Access Compliance Report

Public Rights-of-Way

(Curb Ramps)

Intersection ID: 10028124	Main Street: HAWFIELD_WAY_DR	Cross Street: N/A	Location: SW
ADA ID: 0A3BC348638E	Ramp Type: Perp	Initial Pass/Fail: Fail	Overall Compliance: No
Codes/Mitigation Info/Possible Solution		Field Measurements/Component Compliance

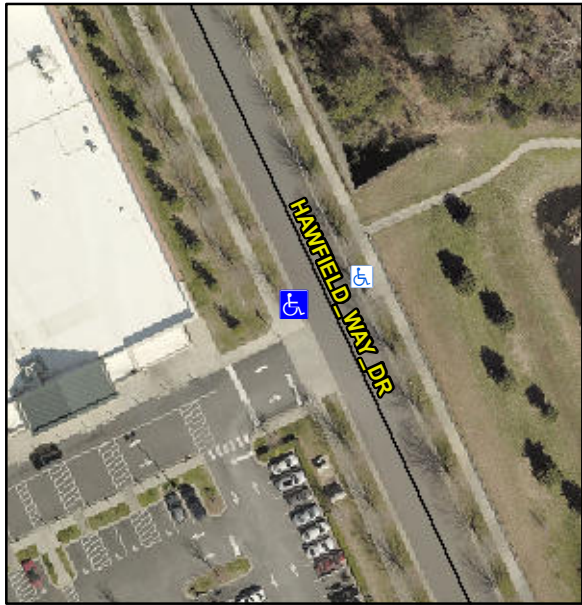
Possible Solutions:					
	Remove & Replace Entire Ramp.					
	Surveyor Notes:					
	N/A					
	PROW/ADA:					
	R304.5.1, R304.2.2					
	Street 1 Name			HAWFIELD WAY DR		
	Stop Condition-Street 2			None		
	Street 2 Name			N/A		
	Stop Condition-Street 1			N/A		
Total Cost:			\$	1850.00

Compliance	Description	Data	Compliance	Description	Data
N/A	Ramp Length (in)	94.0	No	Ramp Slope (%)	10.8
No	Ramp Width (in)	47.5	Yes	Ramp XSlope (%)	2.0
N/A	Flare Type LT	N/A	N/A	Flare Type RT	N/A
N/A	Flare Slope LT (%)	N/A	N/A	Flare Slope RT (%)	N/A
N/A	Flare Traversable LT?	N/A	N/A	Flare Traversable RT?	N/A
N/A	Landing Length (in)	N/A	N/A	DWS Provided?	N/A
N/A	Landing Width (in)	N/A	N/A	DWS Contrast?	N/A
N/A	Landing Slope (%)	N/A	N/A	DWS Length (in)	N/A
N/A	Landing X Slope (%)	N/A	N/A	DWS Full Width?	N/A
N/A	Landing Curb? (Y/N)	N/A	N/A	DWS Offset (in)	N/A
N/A	Shared Landing?	N/A			
N/A	Gutter Ponding?	N/A	N/A	Gutter Slope (%)	N/A
N/A	Gutter Lip Ht (in)	N/A	N/A	Gutter X Slope (%)	N/A
N/A	Painted X Walk1?	No	N/A	Painted X Walk2?	N/A
	X Walk 1 Direction	To NE		X Walk 2 Direction	N/A
N/A	X Walk 1 Width (in)	N/A	N/A	X Walk 2 Width (in)	N/A
	X Walk 1 Slope (%)	2.2		X Walk 2 Slope (%)	N/A
	X Walk 1 X Slope (%)	3.1		X Walk 2 X Slope (%)	N/A
